Item Name: 205 Skidtube bent detail

DESIGN	4	DART AEROSPACE LTD	
DRAWN	RF	HAWKESBURY, ONTARIO, CANADA	
CHECKED	10	DRAWING NO.	REV. E
MFG. APPR.	10	D2580	SHEET 2 OF 8
APPROVED	10	TITLE	SCALE
DE APPR.	10	205 SKIDTUBE ASSEMBLY	NTS
DATE	11.06.21	<small>COPYRIGHT © 1996 BY DART AEROSPACE LTD THIS DOCUMENT IS PRIVATE AND CONFIDENTIAL AND IS SUPPLIED ON THE EXPRESS CONDITION THAT IT IS NOT TO BE USED FOR ANY PURPOSE OR COPIED OR COMMUNICATED TO ANY OTHER PERSON WITHOUT WRITTEN PERMISSION FROM DART AEROSPACE LTD.</small>

DRAWING NO. D2580	TITLE 205 SKIDTUBE ASSEMBLY	REV. E	DART AEROSPACE LTD ENGINEERING ORDER	D.E.O. NO. D2580-E-1	SHEET NO. SHEET 1 OF 1	SCALE NTS
DRAWN <i>UP</i>	CHECKED <i>ASS</i>	MFG. APPR. <i>ER</i>	APPROVED <i>HA</i>	DE APPR. <i>HA</i>		
DATE 11.12.13	DATE 11.12.13	DATE 11.12.13	DATE 11.12.13	DATE 11.12.13	DATE 11.12.13

CHANGE ALL C'BORED WELDED CROSSBOLT SPACERS TO SWAGED SPACERS

SECTION B-B, F-F, I-I
NOT TO SCALE

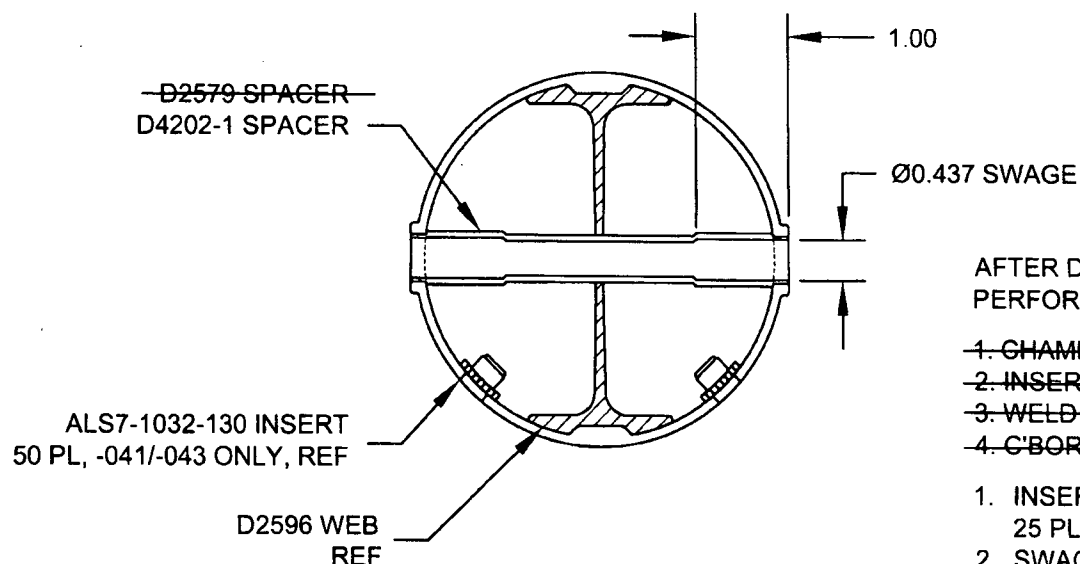
PURPOSE:

PARTS LIST IS AMENDED AS FOLLOWS:

WAS

QTY	QTY	QTY	PART NUMBER	DESCRIPTION
-041	-045	-047		
20	24	25	D2579	CROSS BOLT SPACER

IS

4		* D2579	CROSS BOLT SPACER
20	20	25	D4202-1	SPACER

SECTION B-B, SECTION F-F, & SECTION I-I ARE AMENDED AS FOLLOWS
FOR ALL HOLES THAT WERE ORIGINALLY C'BORED:

*** FOR -045 SKIDTUBE ONLY:**

WELD 4X D2579 SPACERS PER DWG
IN LOCATIONS MARKED "NO C'BORE".
REF SHEET 4 OF DWG.

AFTER DRILLING AND BENDING ASSEMBLY
PERFORM THE FOLLOWING FOR Ø0.508 HOLES ONLY:

1. CHAMFER HOLE 0.060 X 45°
2. INSERT D2579 SPACER (20 PLACES)
3. WELD INTO PLACE AND GRIND FLUSH
4. C'BORE D2579 SPACER TO Ø0.437 X 1.00 DEEP
5. INSERT D4202-1 SPACER, 20 PL (-041) OR 20 PL (-045) OR 25 PL (-047)
6. SWAGE TO Ø0.437 X 1.00 DEEP PER QSI 002
7. TRIM / GRIND FLUSH PER QSI 002
